# Site Accessibility Evaluation

### University Facility Evaluation

**UC Berkeley  
Berkeley, CA 00000**

**Accessibility Evaluation**

### Finding: 1

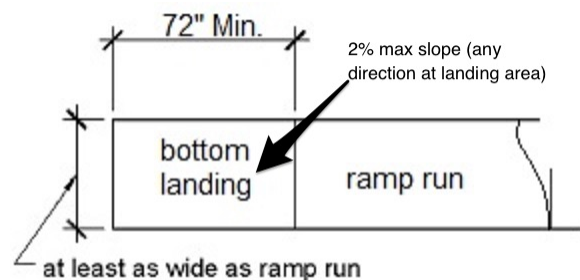
The bottom landing does not provide the minimum area required.

The bottom landings shall extend 72 inches minimum in the direction of ramp run and shall be at least as wide as the widest ramp run leading to the landing.

2019 CBC 11B Section: 11B-405.7.2,  
11B-405.7.3.1

60 inches

Modify landing at least meet minimum requirements for length.

### Finding: 2

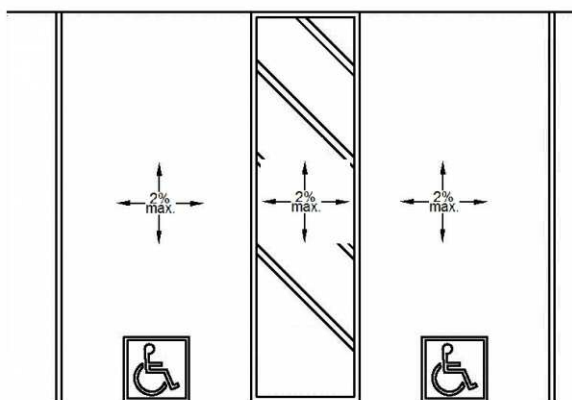
The cross slope (narrow dimension) of the parking stall exceeds 2%.

The running and cross slope in an accessible parking stall and the access aisle must not exceed 2%.

2019 CBC 11B Section: 11B-502.4

2.4% to 3.4%

### Finding: 3

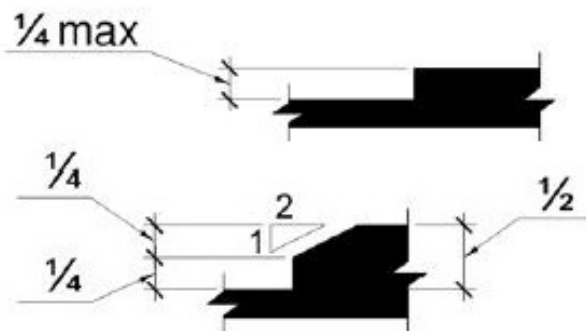
The walkway contains abrupt vertical edges and/or variations over a 1/4 inch.

1/4 inch is the maximum vertical rise. Changes in level between 1/4 inch and 1/2 inch must be beveled at 1:2 or less.

Changes in level greater than 1/2 inch must be by way of a ramp.

| Citation:   | As Built:    | Budgeting Range:     |
|---|--------------|----------------------|
| 2019 CBC 11B Section: 11B-303.2, 11B-303.3          | 1 1/4 inches | \$1,500 - \$4,500.00 |

### Finding: 4

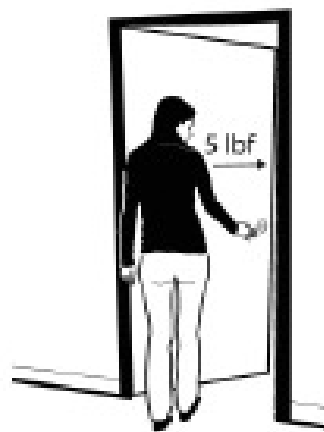
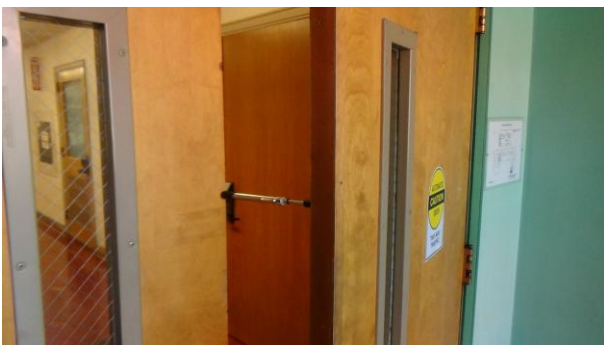
The door exceeds the maximum force to open.

Doors shall have a maximum opening force of 5 pounds.

These forces do not apply to the force required to retract latch bolts or disengage other devices that hold the door or gate in a closed position. Door closers and gate closers shall be adjusted so that from an open position of 90 degrees, the time required to move the door to a position of 12 degrees from the latch is 5 seconds minimum.

2019 CBC 11B Section: 11B-404.2.9

10 lbs / 3.5 second  
backcheck

Adjust closer to require no more than 5 pounds of force to open.

### Finding: 5

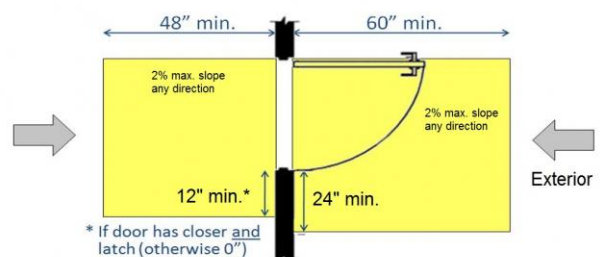
The landing at the entrance door exceeds 2% slope.

Exterior doors must have a landing on the pull side that is a minimum of 60 inches in depth perpendicular to the door in a close position by a minimum width dimension of 24 inches plus the door width. The additional 24 inches must extend past the door on the latch side. The entire landing must be free of obstructions and must be flat (2% max. slope is considered flat in any direction).

2019 CBC 11B Section: 11B-404.2.4.4

2.4% to 3.3%

### Finding: 6

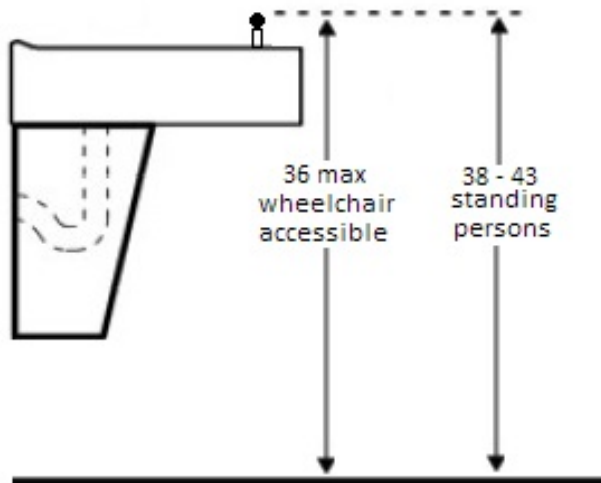
The total number of drinking fountains are not equally divided between those that are accessible to wheelchair users and those that are available to standing persons.

Where more than two are provided, 50 percent of the total number of drinking fountains provided shall be accessible to wheelchair users and 50 percent available to standing persons.

2019 CBC 11B Section: 11B-211.3

Missing wheelchair accessible drinking fountain

### Finding: 7

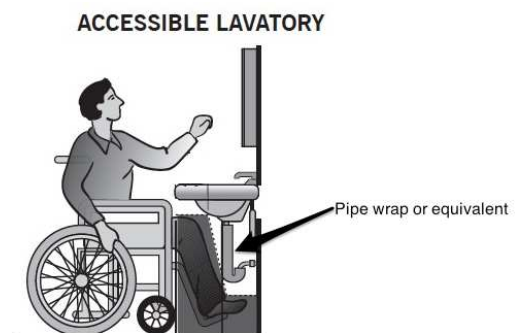
The water and drain pipes under the lavatory are not adequately insulated.

Water supply and drain pipes under lavatories and sinks shall be insulated or otherwise configured to protect against contact. There shall be no sharp or abrasive surfaces under lavatories and sinks.

2019 CBC 11B Section: 11B-606.5

Missing

### Finding: 8

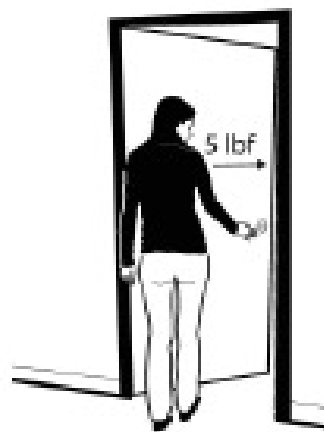
The door exceeds the maximum force to open.

Doors shall have a maximum opening force of 5 pounds.

2019 CBC 11B Section: 11B-404.2.9

12 lbs / 3.2 seconds

Adjust closer to require no more than 5 pounds of force to open.

Corrected by maintenance on 6/29/2019

### Finding: 10

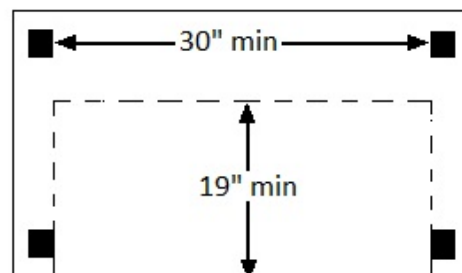
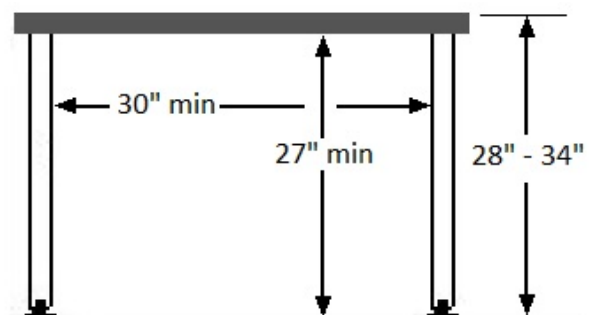
There are no accessible work surfaces.

At least 5% of each type of work surface must be accessible and must be dispersed throughout the space or facility containing work surfaces. The accessible surface must be on an accessible route (36 inches minimum) and have knee and toe spaces at least 27 inches high, 30 inches wide and 19 inches deep. The tops of work surfaces shall be 28 inches to 34 inches from the floor or ground.

2019 CBC 11B Section: 11B-226.1

None provided
